The City of St. Louis (City) and the Missouri State Highway Department (MSHD) have long recognized Route 755 as a key part of the transportation plan necessary for the revitalization of the City. Construction of the freeway (shown on Figure 1) will relieve serious traffic flow restrictions at the present interchange of I-44 and I-55, on north-south City arterials, on residential streets, and I-70--I-55 downtown. The existing freeway system was designed with Route 755 as an integral part of the overall system to handle the area's anticipated future traffic growth. Without this vital link, the entire system is inadequate and cannot function as planned.

In April, 1979, the City contracted with Booker Associates, Inc., (Booker) for professional and technical services to review Route 755's preliminary design as prepared by MSHD in terms of specific engineering design aspects and mitigation of various adverse environmental impacts.

ROUTE 755, ST. LOUIS CITY
North South Distributor Freeway

Plate IV

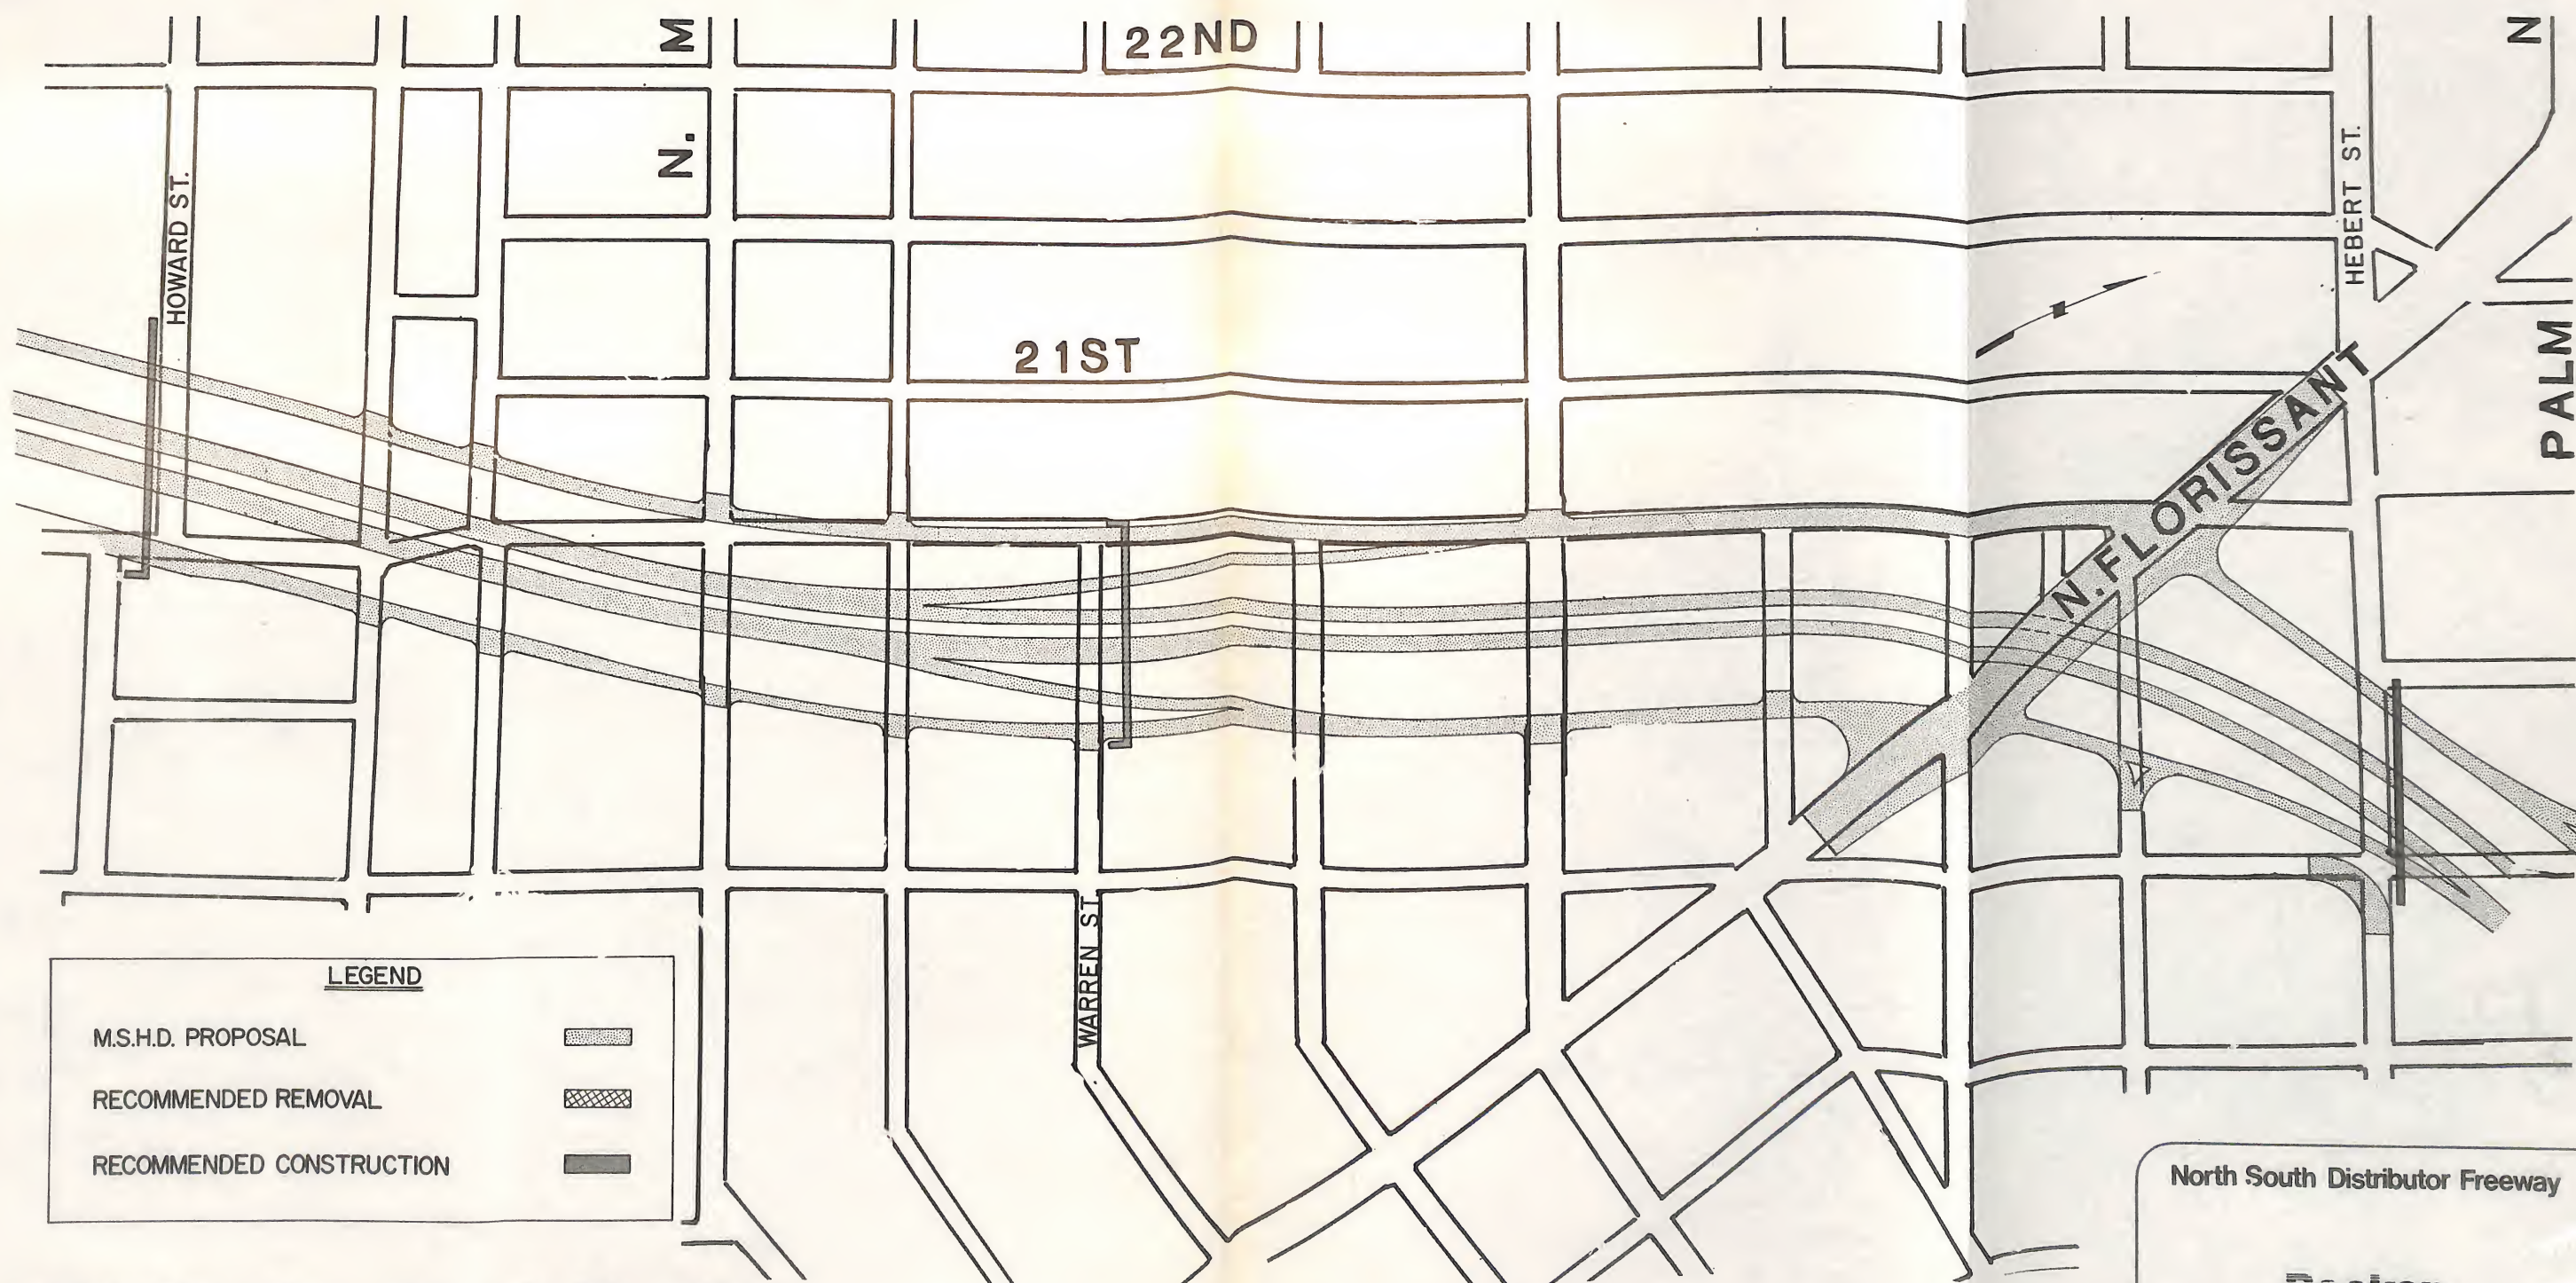
A preliminary analysis was made to determine the feasibility of revising the southern terminus of Route 755 with I-44 and I-55 from an elevated to a depressed section. The study indicated this modification was possible through increased costs associated with safety problems of existing traffic intermixed with construction activities, movement of excess earth materials, and demolition/construction. Any decision revising this section of the facility must involve trade-offs concerning of adverse socio-economic, noise, and aesthetic impacts against monetary and safety costs/benefits.

A preliminary analysis was made to determine the feasibility of revising that portion of the proposed facility from an elevated to a depressed section, as shown in Figures 2 and 3. This analysis indicated that the modifications were capable of being accomplished, although at a cost greatly increased compared to the proposed design. The three major considerations in providing a depressed section in this portion of the facility are the maintenance of existing traffic, earthwork, and construction costs; each of which are addressed in specific detail below.

Consequently, in evaluating the feasibility of depressing the southern portion of Route 755, the above costs must be carefully weighed against the adverse socio-economic, noise, and aesthetic impacts experienced by the adjacent neighborhood if that section remains elevated. The decision to be made by the City and MSHD should be based on a detailed analysis of the costs and benefits as specified in the DEIS and this report. Any trade-off should be the result of engineering and planning analyses and the citizen participation process.
